**Re: Defect Information Report – Supplemental Report No. 2  
07V-357, FL-505, TRW P2 Steering Column Tilt Plate Bolts**

## Subject: TRW Steering Columns

**Models Affected: Specific Freightliner Century Class S/T, Columbia, and Coronado vehicles with TRW global adjustable upper steering columns manufactured between February 20, 2006, and July 6, 2007.**

November 2007  
 FL505A  
 NHTSA #07V-357

**Fig. 2, Location of Tilt Plate Bolts**

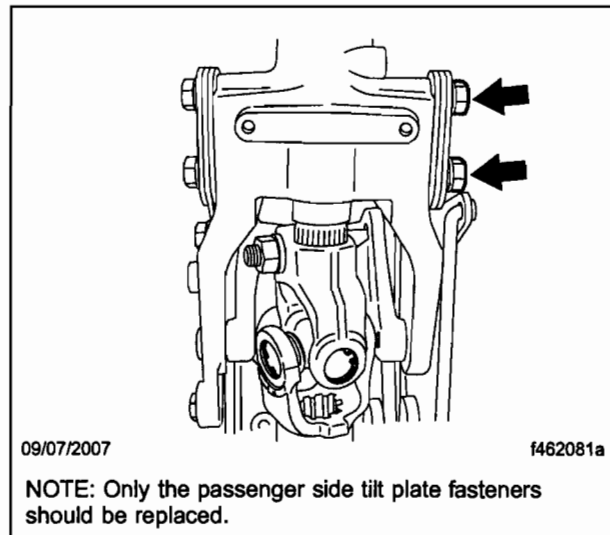
The upper tilt plate bolts on certain TRW Global steering columns may loosen with use and fall out. Steering columns with missing bolts may fracture at the steering column bracket and will not hold the steering wheel in position. Loss of steering wheel position may cause the steering to respond differently than expected and could result in a possible vehicle crash without prior warning.

1. Remove the nut and washer that holds the bottom of the dash knee bolster to the frontwall, then remove the bolster by pulling its upper corners away from the dash.
2. Remove the four column cover fasteners on the back of the column, then remove the covers.
3. Verify that passenger-side bolts are present. See **Fig. 2**. If any bolts are missing, install the new bolts and Nord-Lock washers from the kit.

4. If any bolts are present, remove them, one at a time, and install the new bolts and Nord-Lock washers from the kit; see **Fig. 3**. Tighten the bolts 32 to 35 lbf-ft (43 to 47 N·m). *If either of the bolts cannot hold the specified torque, replace the column.* **NOTE: It is expected that very few or no steering columns will require replacement. All steering columns will be returned for supplier inspection.**
